Access Compliance Report

Public Rights-of-Way

(Curb Ramps)

Intersection ID: 10022634	Main Street: CARMEL_RD	Cross Street: N/A	Location: SE
ADA ID: A320CE7C4399	Ramp Type: PerpDiag	Initial Pass/Fail: Fail	Overall Compliance: No
Severity Score: 21.25			
Codes/Mitigation Info/Possible Solution		Field Measurements/Component Compliance

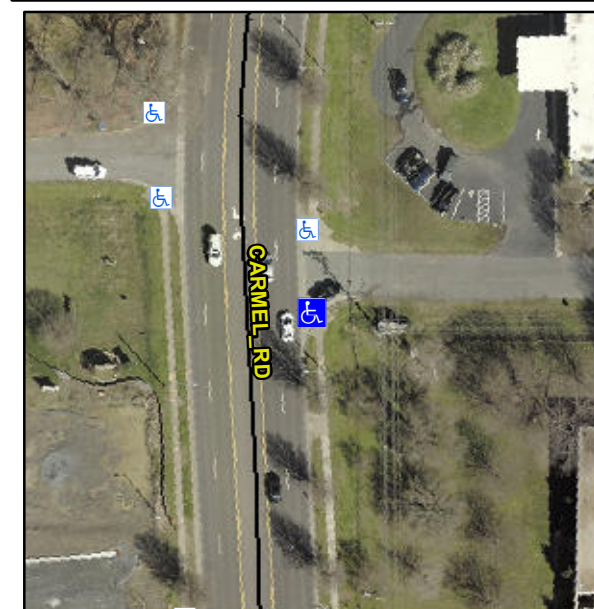
R304.5.1, R304.5.3

Compliance	Description	Data	Compliance	Description	Data
N/A	Ramp Length (in)	65.0	Yes	Ramp Slope (%)	7.4
No	Ramp Width (in)	41.5	No	Ramp XSlope (%)	5.6
N/A	Flare Type LT	N/A	N/A	Flare Type RT	N/A
N/A	Flare Slope LT (%)	N/A	N/A	Flare Slope RT (%)	N/A
N/A	Flare Traversable LT?	N/A	N/A	Flare Traversable RT?	N/A
N/A	Landing Length (in)	N/A	N/A	DWS Provided?	N/A
N/A	Landing Width (in)	N/A	N/A	DWS Contrast?	N/A
N/A	Landing Slope (%)	N/A	N/A	DWS Length (in)	N/A
N/A	Landing X Slope (%)	N/A	N/A	DWS Full Width?	N/A
N/A	Landing Curb? (Y/N)	N/A	N/A	DWS Offset (in)	N/A
N/A	Shared Landing?	N/A			
N/A	Gutter Ponding?	N/A	N/A	Gutter Slope (%)	N/A
N/A	Gutter Lip Ht (in)	N/A	N/A	Gutter X Slope (%)	N/A
N/A	Painted X Walk1?	No	N/A	Painted X Walk2?	No
	X Walk 1 Direction	To NE		X Walk 2 Direction	To NW
N/A	X Walk 1 Width (in)	N/A	N/A	X Walk 2 Width (in)	N/A
	X Walk 1 Slope (%)	1.6		X Walk 2 Slope (%)	3.9
	X Walk 1 X Slope (%)	6.0		X Walk 2 X Slope (%)	0.7

Remove & Replace Curb Ramp With Two New Directional Ramps or Equivalent.
